REMARKS

Claims 20-28 are rejected under 35 U.S.C. 103(a) as being unpatentable over the applicant's prior art figure (APAF) is view of Yamazaki et al. (US 6,677,613 B1). Response to the Office Action identified above is listed below.

AMENDMENTS TO THE DRAWINGS

Fig. 8

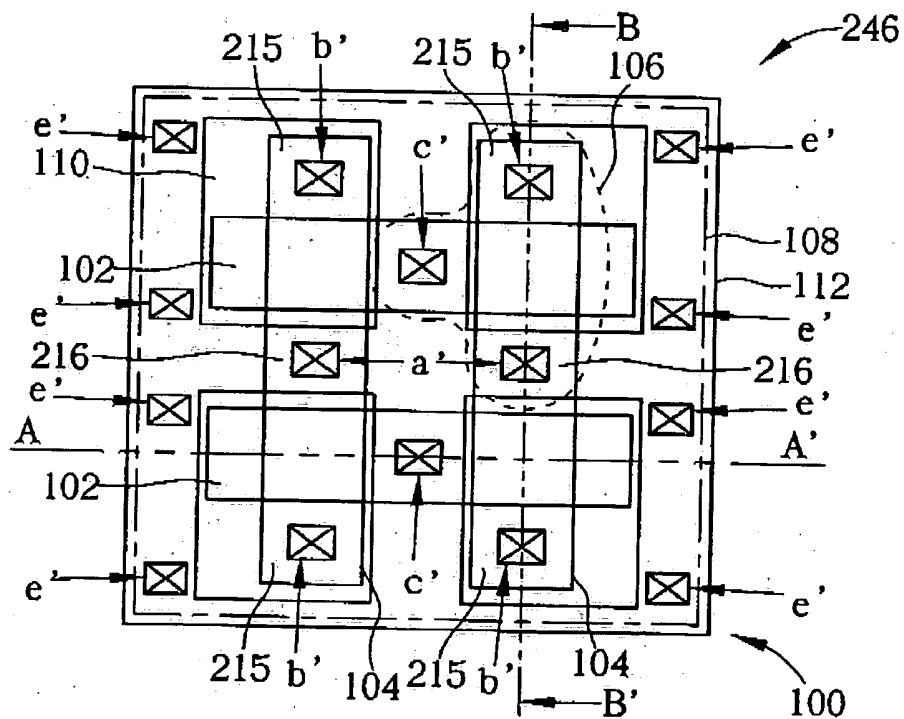
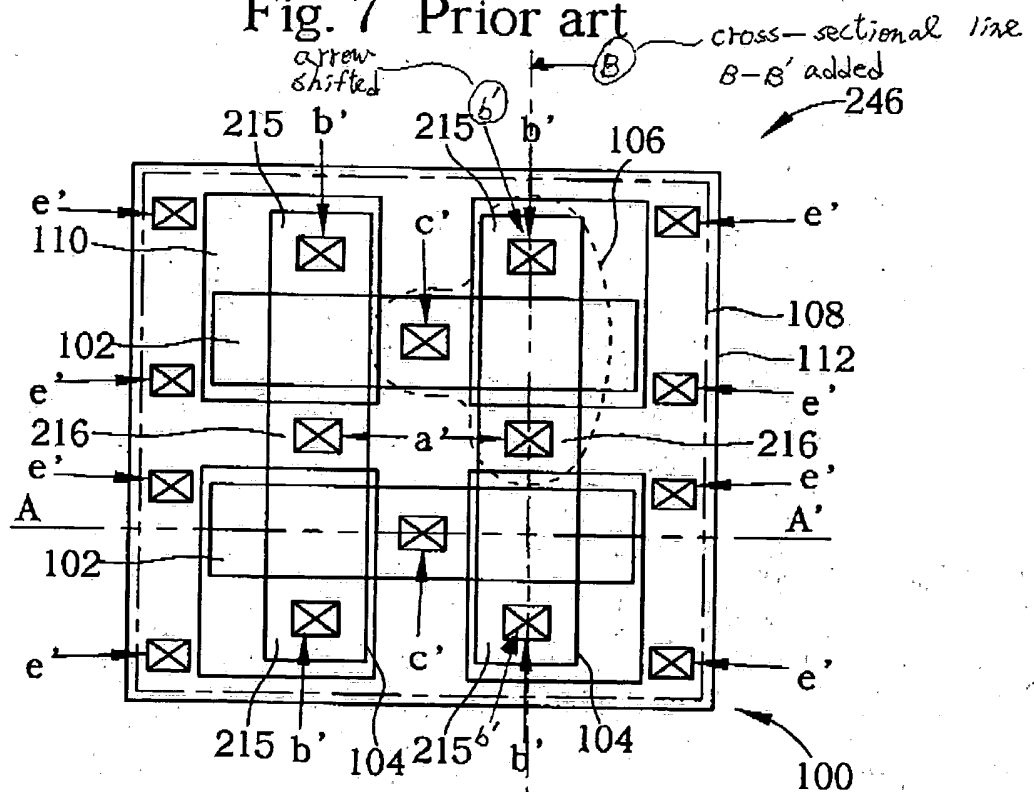
Claim 20 is amended in the above AMENDMENTS TO THE CLAIMS section. Fig.8 is amended and Fig.15 is added in the above AMENDMENTS TO THE DRAWINGS section and paragraphs [0023], [0026], [0029] are amended in the AMENDMENTS TO THE SPECIFICATION section. In Fig.11, the gate layer (214) is above the source/drain regions (215/216) because this cross-sectional diagram is drawn along A-A' in Fig.8. Actually, either of the source region 215 and the drain region 216 is in the

5 The attached sheets of drawing include changes to
Fig. 8 and a new added sheet of Fig.15. The sheet, which
includes Fig. 7-8, replaces the original sheet
including Fig. 7-8. In Figure 8, a cross-sectional line
B-B' previously omitted has been added and the arrows
for indicating two source contact plugs b' are shifted.
10 Fig.15, which is a cross-sectional diagram along line
B-B' in Fig.8, has been added in order to illustrate
the sites for sources, drains, and gates, which has
already been shown in Fig.8, more clearly.

Fig. 15

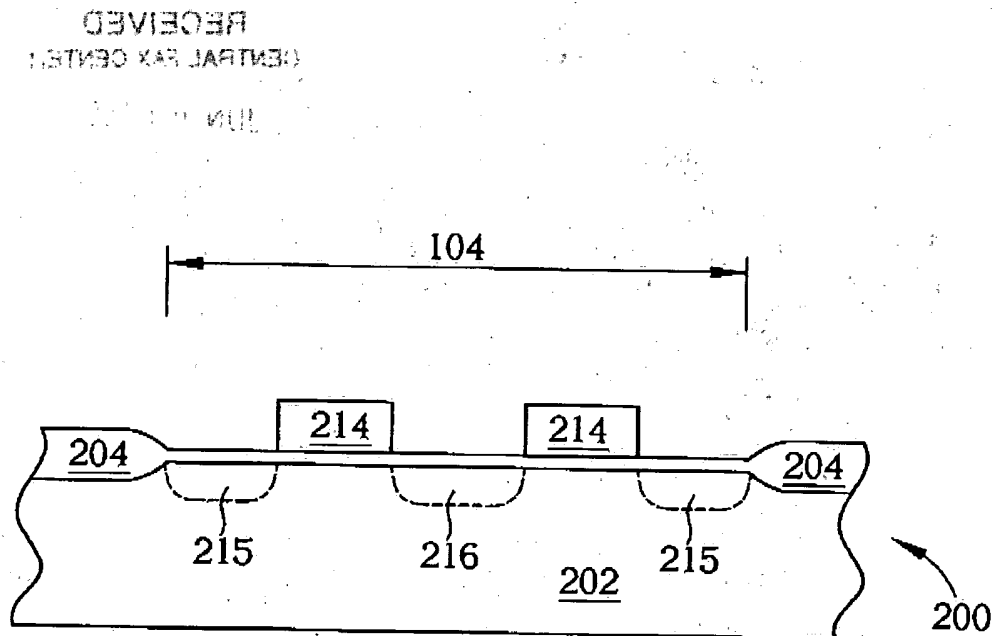
Fig. 15 is drawn along line B-B' in Fig. 8 such that at least one complete transistor 106 is shown in a cross section so as to illustrate the relative sites for sources 215, drains 216, and gates 214 more clearly. In Fig. 15, it is very obviously that the source 215 and the drain 216 are in the active area 104 not covered by the gate 214. No new matter is added.
